THE CORPORATION OF THE CITY OF RICHMOND HILL

Addendum #1

RFQ-2510155

Connor Building Renovation and Retrofit

a) Water line clarification

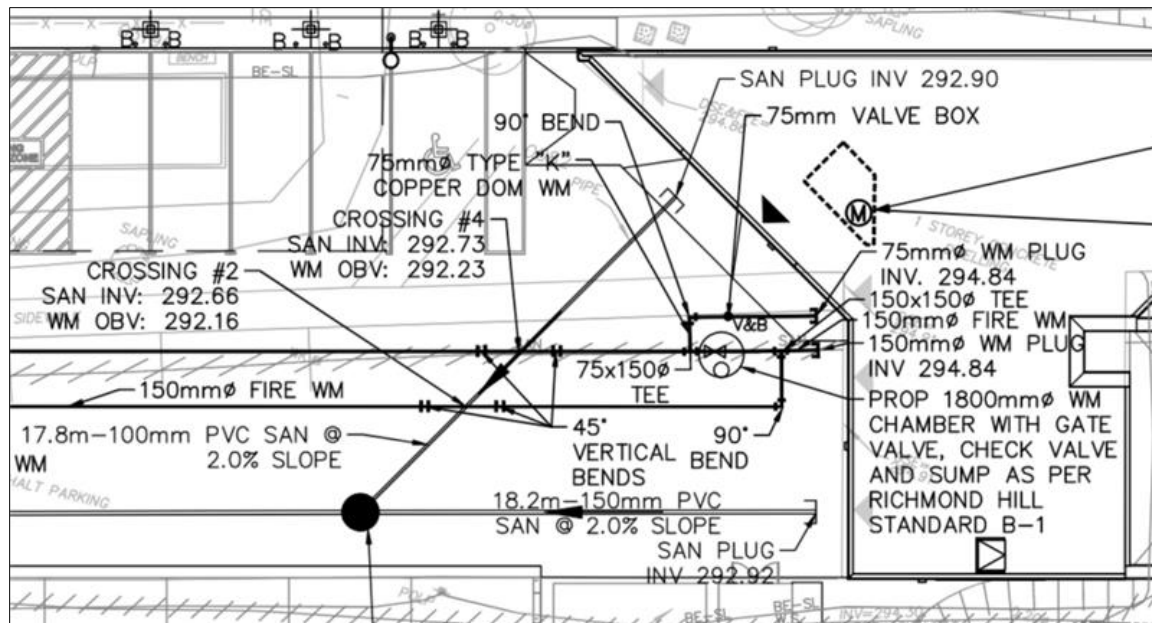
See figure above. Note 75mm water line from valve chamber to building to be located to north of valve chamber to avoid crossing the 150mm fire water line.
